## BOARD OF WORKS SPECIAL MEETING

Robert Pate, DLZ presented change orders 8-9-10 for the renovation project at City Hall located at 314 E Washington.

**AIA**<sup>®</sup>**Document G701™ – 2017****Change Order**

<b>PROJECT:</b> <i>(Name and address)</i> Greensburg City Hall Renovation 314 West Washington Street, Greensburg Indiana 47240	<b>CONTRACT INFORMATION:</b> Contract For: General Construction Date: 12/07/2020	<b>CHANGE ORDER INFORMATION:</b> Change Order Number: 008 Date: 04/16/2021
<b>OWNER:</b> <i>(Name and address)</i> Joshua Marsh, Mayor  314 West Washington Street, Greensburg Indiana 47240	<b>ARCHITECT:</b> <i>(Name and address)</i> DLZ Indiana, LLC  138 N. Delaware St, Indianapolis, IN 46204	<b>CONTRACTOR:</b> <i>(Name and address)</i> Construction Planning and Management, Inc. (CPM) 10053 N. Hague Rd, Indianapolis, Indiana 46256

RENOVATION OF THE GREENSBURG CITY HALL	REMARKS:	SKETCH NUMBER
			E2.5 (R)
	CLERK TREASURER BILLING POWER PLAN	PROJECT NO:2063-1044-90	
		DATE: 02/11/2021	ELECTRICAL

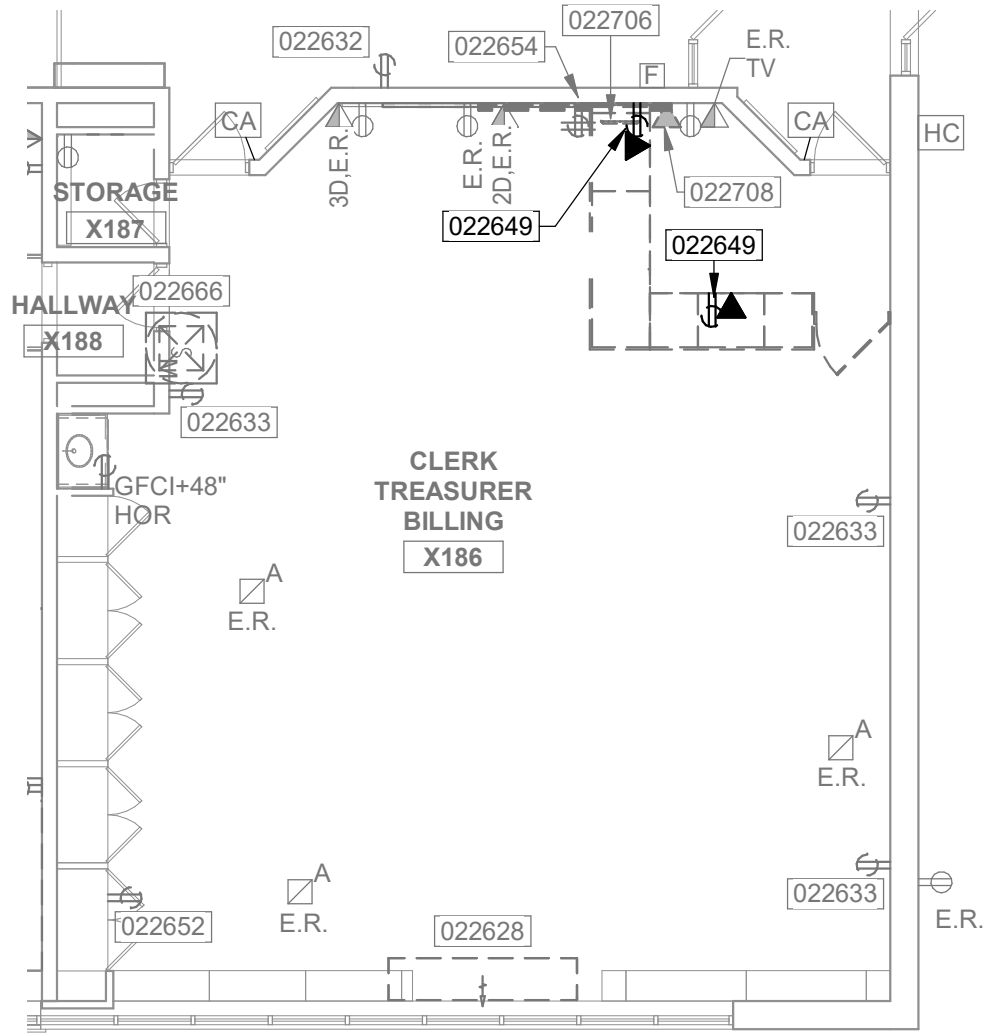
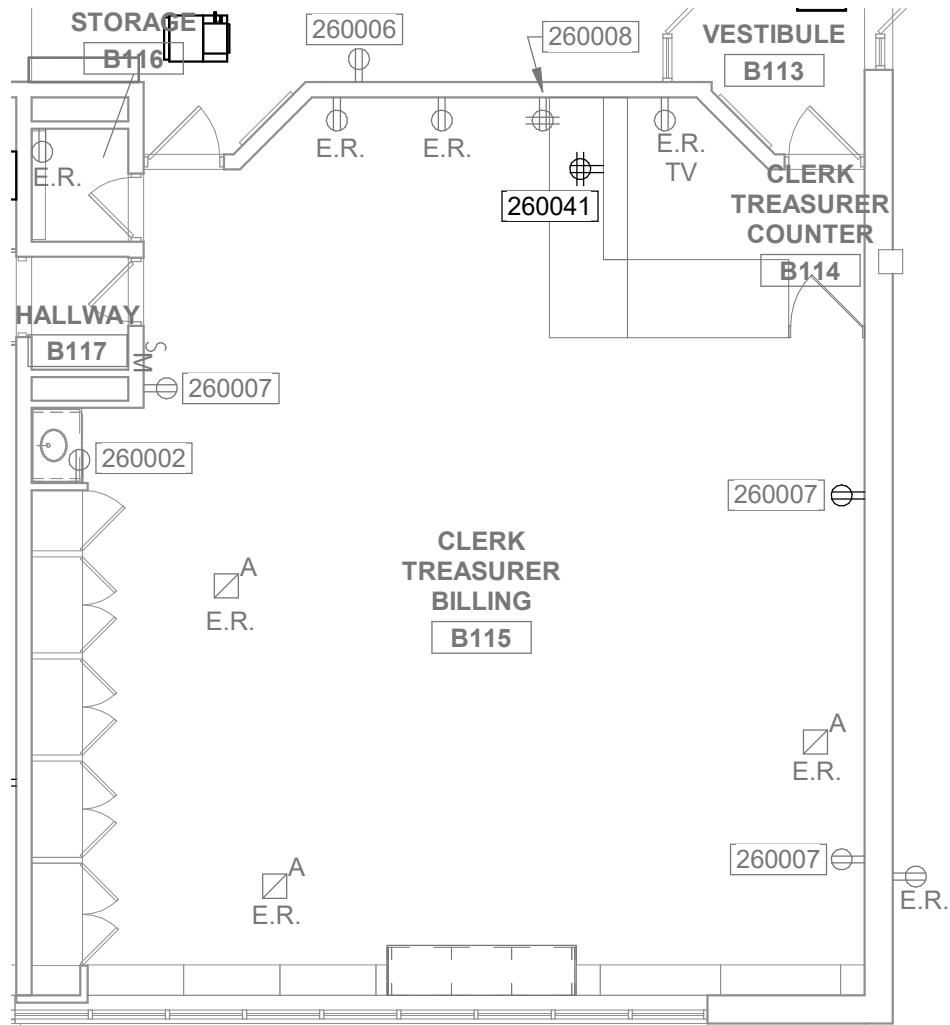
- ED2.4 CLERK TREASURER -REMOVE EXISTING POWER \$200
- E2.4 ASSEMBLY RM. POWER- NOTE INSTALL UNDER FLOOR RACEWAYS AND POWER \$980  
INSTALL POWER OUTLETS AND USB PORTS IN WIRE MOLD \$1330
- E2.5 ASSEMBLY COUNCIL LIGHTING AND ELECTRICAL CHANGES \$320
- E3.4 ASSEMBLY LIGHTING PLAN \$8780
- E3.5 ASSEMBLY LIGHTING ELEV A TYPE 2 MOCK UP OF FULL SCALE SHEET LIGHTING AS DIRECTED \$2400,  
KEYNOTES FOR ACCUAL INSTALL INCLUDE LIGHT PANELS, AMPS, CONTROLLERS AND POWER SUPPLYS  
\$4500
- E3.6 ASSEMBLY LIGHTING ELEV B TYPE 2 MOCK UP OF FULL SCALE SHEET LIGHTING AS DIRECTED \$2400  
KEYNOTES FOR ACCUAL INSTALL INCLUDE LIGHT PANELS,AMPS, CONTROLLERS AND POWER SUPPLYS  
\$4500
- E3.7 SAME AS TWO PREVIOUS ABOVE ELEV C MOCK UP \$2400 ACCUAL EQUIPMENT INSTALL \$4500
- E4.4 ASSEMBLY ROOM SYSTEM PLAN C  
INSTALL CAT 6 COMMUNICATION CABLES AND JACKS ROUTED TO NEW IDF RACK \$670

<small>ARCHITECTURE • ENGINEERING • PLANNING SURVEYING • CONSTRUCTION SERVICES</small> DLZ INDIANA, LLC	RENOVATION OF THE GREENSBURG CITY HALL	REMARKS:	SKETCH NUMBER
			E3.5 (R)
	ASSEMBLY ROOM COUNTER LIGHTING - ELEVATION A (TYP.2)	PROJECT NO:2063-1044-90	
		DATE: 02/11/2021	ELECTRICAL

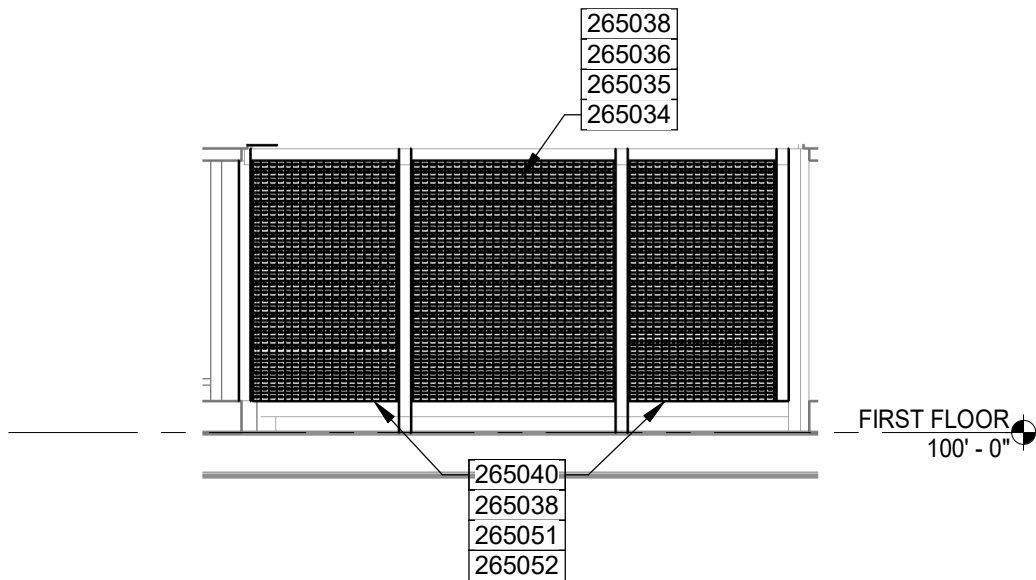
- 265038 CONTRACTOR SHALL PROVIDE FULL SCALE MOCK-UP OF FLEXIBLE SHEET LIGHTING TO BE INSTALLED BEHIND LOGO/FROSTED GLAZING. MOCK-UP SHALL INCLUDE FROSTED GLASS AND MATERIAL REFLECTANCES WITHIN THE SPACE. PROVIDE EVEN ILLUMINATION OVER/THROUGH THE FROSTED GLASS SURFACE ELIMINATING INDIVIDUAL LED MODULE VIEWS. OWNER/ENGINEER AND ARCHITECT SHALL BE PRESENT FOR MOCK-UP AND SHALL PROVIDE FINAL APPROVAL.

- 265039 FURNISH AND INSTALL SEVENTEEN (17) 12" X 24" FLEXIBLE RGBW LED SHEET LIGHTING MOUNTED ON GYPSUM BOARD SUBSTRATE FOR BACK LIGHTING. EACH SHEET TO BE LIKE KELVIX #FF2-RGBW-20W-30K-IP20-24V OR APPROVED EQUAL WITH 120 DEGREE BEAM SPREAD, 144 LEDS PER SQFT, 90 CRI, 20W PER SQFT AT 24V. SHEET TO BE SCREW MOUNTED ON GYPSUM BOARD SUBSTRATE PER MANUFACTURERS RECOMMENDATION.

- 265042 FURNISH AND INSTALL EIGHT (8) 96W, 24V CLASS 2 SUPPLY DRIVER FOR POWERING FLEXIBLE SHEET LIGHTING. DRIVER TO BE LIKE KELVIX #ULV96 OR APPROVED EQUAL. DRIVER TO BE MOUNTED IN CAVITY BEHIND GYPSUM BOARD SUBSTRATE, FIELD VERIFY EXACT LOCATION. FURNISH AND INSTALL EIGHT (8) 72 INCH RGB-W POWER FEED CABLE LIKE KELVIX #FML-5C-6 OR APPROVED EQUAL. PROVIDE CONNECTION PER MANUFACTURERS RECOMMENDATION FROM DRIVER TO EACH FLEXIBLE SHEET.

- 265043 FURNISH AND INSTALL EIGHT (8) 4 CHANNEL, 5AMP/CHANNEL RF RECEIVER FOR CONTROLLING FLEXIBLE SHEET LIGHTING. RECEIVER TO BE LIKE KELVIX #RFR-A-4C-5A OR APPROVED EQUAL. RECEIVER TO BE MOUNTED IN CAVITY BEHIND GYPSUM BOARD SUBSTRATE, FIELD VERIFY EXACT LOCATION. PROVIDE CONNECTION PER MANUFACTURERS RECOMMENDATION FROM RECEIVER TO FLEXIBLE SHEET(S) AS REQUIRED.

<small>ARCHITECTURE • ENGINEERING • PLANNING SURVEYING • CONSTRUCTION SERVICES</small> DLZ INDIANA, LLC	RENOVATION OF THE GREENSBURG CITY HALL	REMARKS:	SKETCH NUMBER
			E4.4 (R)
	ASSEMBLY ROOM COUNCIL SYSTEMS PLAN	PROJECT NO: 2063-1044-90	
		DATE: 02/11/2021	ELECTRICAL

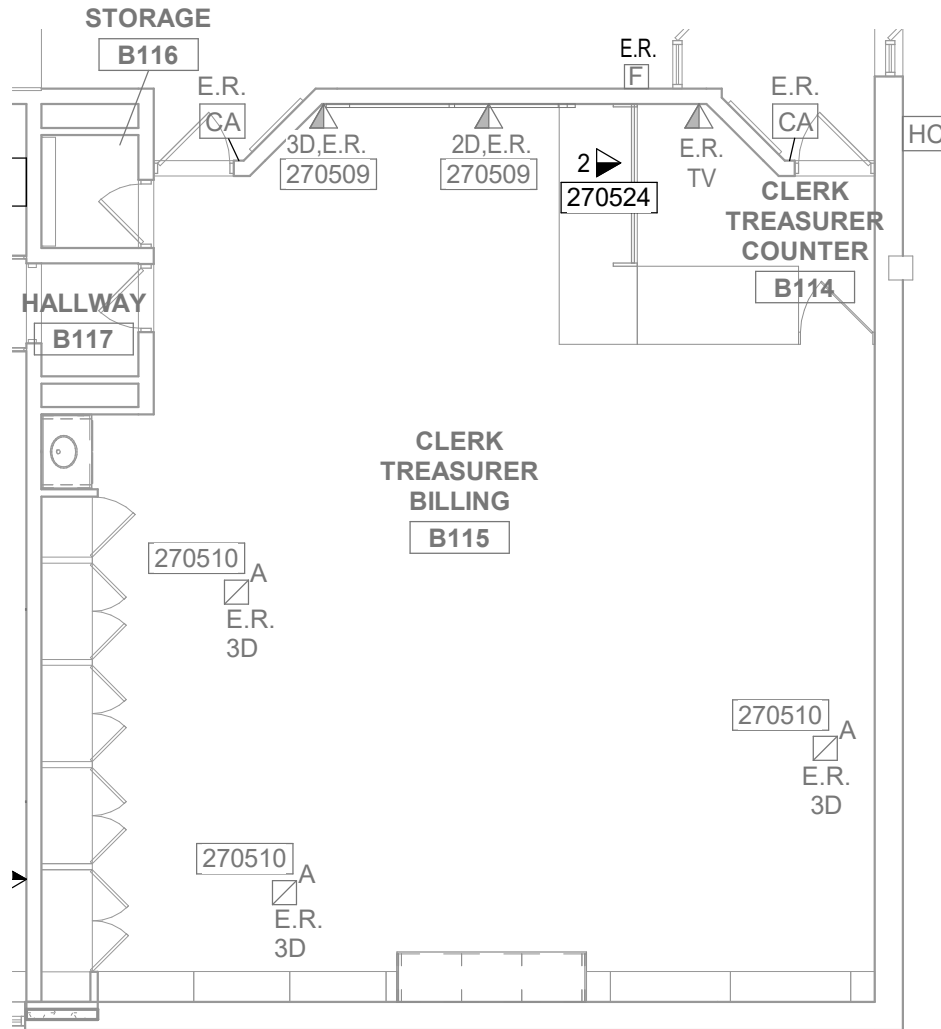
- 270523 FURNISH AND INSTALL (2)-1" CONDUITS FROM COUNTER BACK STUBBED OUT ABOVE ACCESSIBLE CEILING FOR COMMUNICATIONS CABLING. ROUTE CONDUIT BELOW RAISED FLOOR OVER AND UP EAST WALL WHERE SHOWN. PROVIDE WITH PULLSTRINGS AND BUSHINGS.
